ADDENDUM NO. 6

Project Number: R.100644.001

R.100644.001
E-132
COW AND GOAT BARN

Detail Sheet E-132 TYPE 'L' LIGHTING FIXTURE.

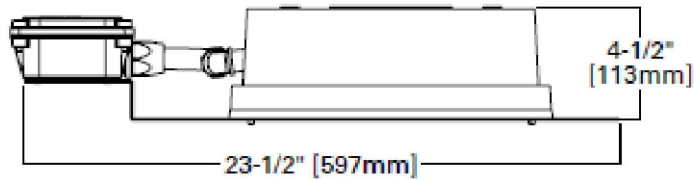
-
5. Detail Sheets
 1. Add detail sheet E-132 TYPE 'L' LIGHTING FIXTURE.

- LAMP: 46WATT, 32 LEDS, 3,000K, 80 CRI.
- DRIVER: WITHSTAND 10KV TRANSIENT LINE SURGE.
- VOLTAGE: UNIVERSAL 120-277VOLTS, SINGLE PHASE 60HZ.
- GENERAL: RECESSED CANOPY LIGHT WITH WET LOCATION DRIVER ENCLOSURE, IP66 RATED.
- HOUSING: HEAVY DUTY CAST ALUMINUM WITH ALUMINUM MOUNTING FRAME.
- OPTICS: DEDICATED CAVITIES FOR ARRAY OF INDIVIDUAL LED'S TO MAXIMIZE EFFICIENCY AND CONTROL OF DISTRIBUTION OUTPUT. A GLARE-REDUCING OPTICAL SYSTEM TO ENHANCE VISUAL COMFORT AND MAXIMIZE DELIVERED LUMENS WHILE MINIMIZING GLARE.
- FINISH: POLYESTER POWDER COAT PAINT 2.5 MIL NOMINAL THICKNESS. LENS FRAME AND TRIM TO BE BLACK.
- WARRANTY: 5 YEARS.
